## REQUEST FOR QUALIFICATIONS

### E-20 Wurzbach Parkway

Solicitation No.: PS-00019

Questions and Answers | January 28, 2016

### E-20 PROJECT LOCATION MAP

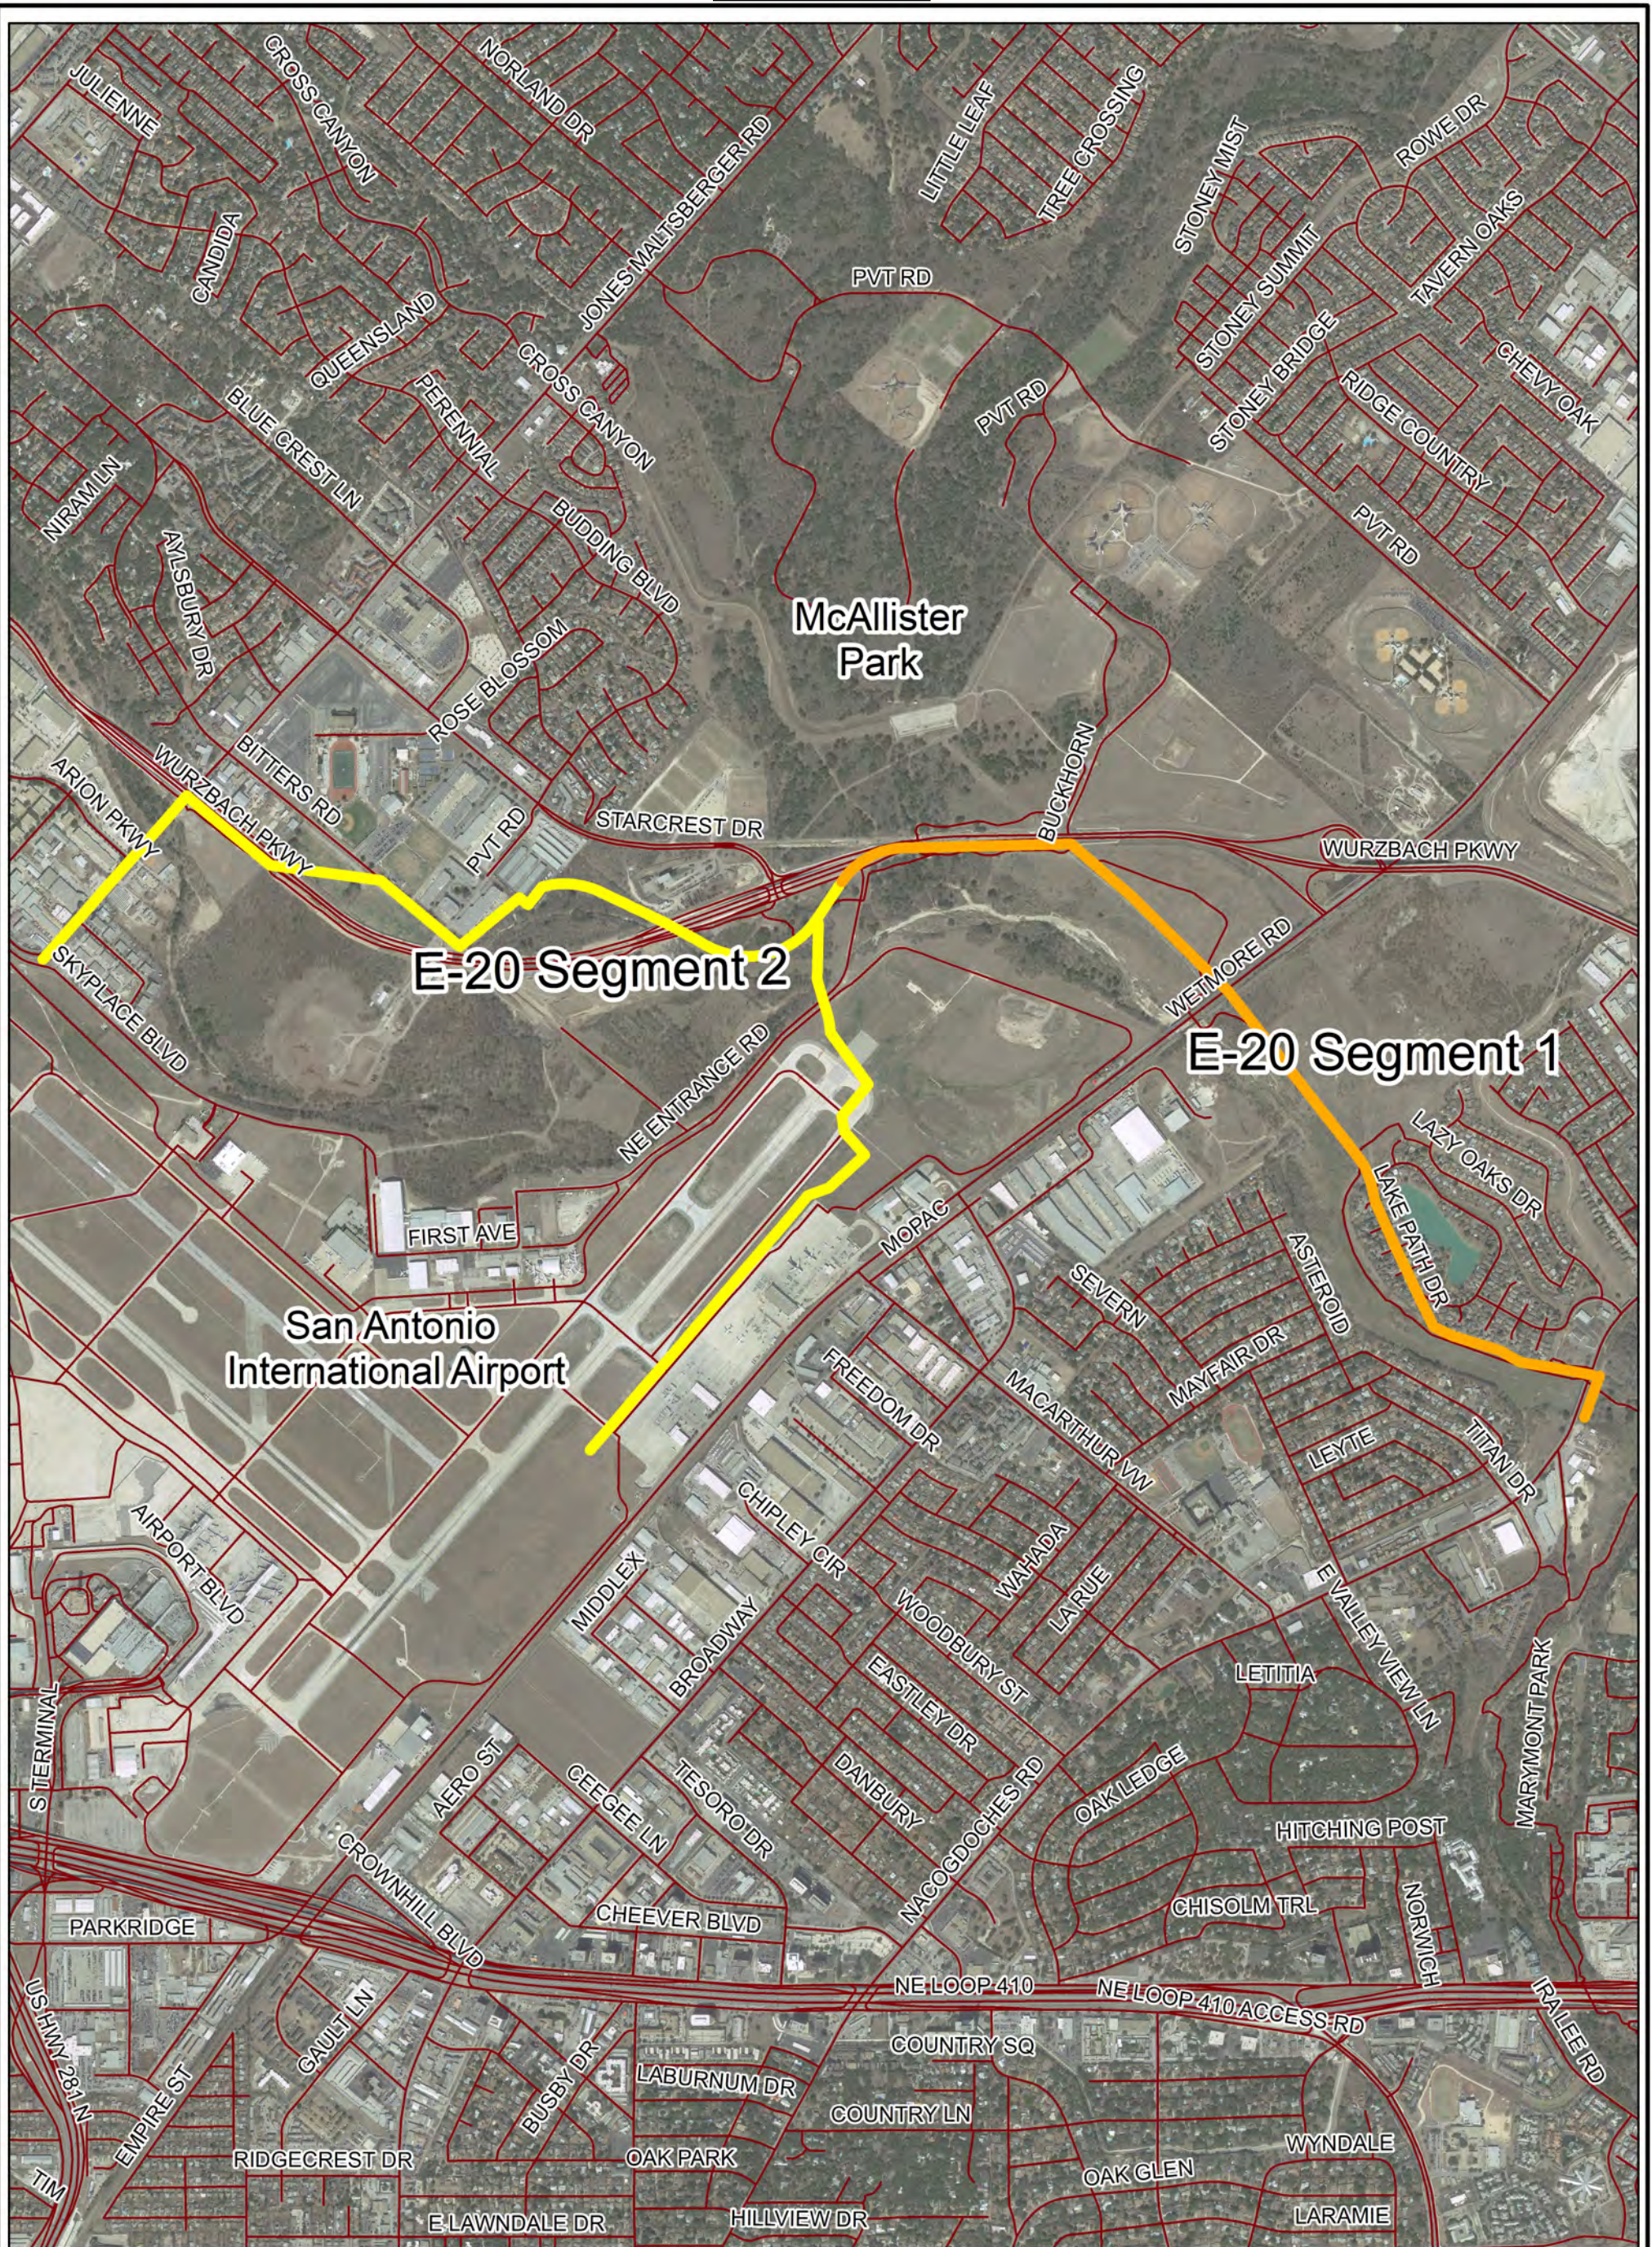
2. In section I.B., page 1 of the RFQ, the Scope of Services for Segment 2 describes a portion of the sewer main Project “includes a branch that extends into the San Antonio International Airport”. There are two locations where sewer mains connect to the Project route that has sewer mains that extends into SAIA: A) there is a 12” PVC sewer main (that connects to the 36” RCP sewer main near Wurzbach Pkwy and NE Entrance Rd) which extends southerly into SAIA; B) and also, there is a 12” PVC sewer main (that connects to the 8” PVC sewer main at E. Nakoma and Jones Maltsberger Rd) which extends southeasterly into SAIA and further into SAIA it branches into two more sewer mains. Please verify which sewer main SAWS is referring to that extends into SAIA that is a part of the Project Scope of Services.

3. Can you please provide more specific information where Segment 1 actually begins and the location of the existing siphon south of Nacodoches Rd that is referenced to by SAWS? Clarification is needed since there is another existing SAWS siphon in the vicinity that is also south of Nacodoches Rd.

- 5. I would like to find out if there is a map of the project segment to see if there might be any tunnel or trenchless segments required. This will help us decide as to whether we will pursue the project (E20 Wurzbach Parkway).**

- 8. Is there is map available that shown the existing sewer alignment, in particular the branch that extends to the Airport?**

*SAWS’ intention was to refer to the first main (A) that branches off near Wurzbach Parkway and the NE Entrance Road. To further clarify, please reference the Project Location Map, Attachment A, which identifies the sewer mains for both segments of the Project.*

*Segment 1 begins at the downstream end of the siphon (the Project includes this siphon) that is most directly adjacent to the sewer main crossing Nacogdoches Road and extends upstream to a point near the intersection of Wurzbach Parkway and NE Entrance Road. To further clarify, a map exhibit is being provided with these responses.*

*Please reference Attachment A.*

*Yes, please reference Attachment A.*
